VALIDATION OF THE REVISED  
MONITORING PLAN:

**Mokpo Landfill Gas Recovery Project  
for Electricity Generation**

**UNFCCC Ref. No. 2834**

**REPORT No. 2010-09**

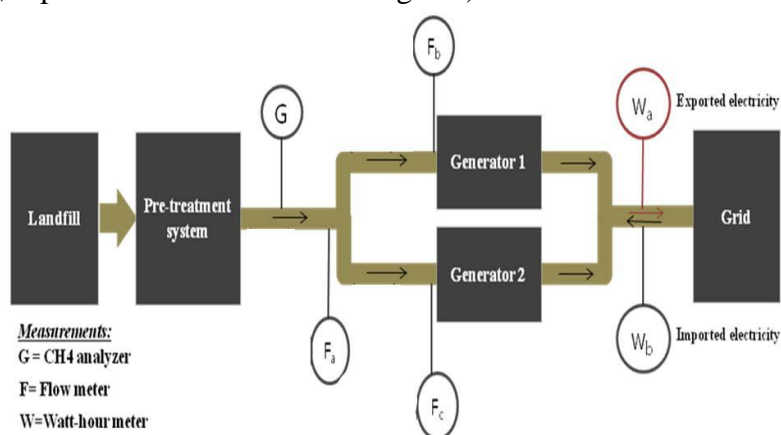
## (2) Modified parameters

$LFG_{electricity,y}$  parameter's description is modified.

In the parameter description of  $LFG_{electricity,y}$ , The data unit of  $LFG_{electricity,y}$  is changed from  $m^3/y$  to  $Nm^3/y$  in line with the actual monitoring situation and additional comment is inserted that “No separate monitoring of temperature and pressure when expressing LFG volumes in normalized cubic meters” Which is assessed together with above (1) T and P parameters.

As monitoring parameters revised, some descriptions related the excluded parameters are also changed in monitoring plan.

- The figure of the location monitoring facilities in PDD B.7.2 reflects the parameters changes. (Separate T, P points are excluded in the figures)
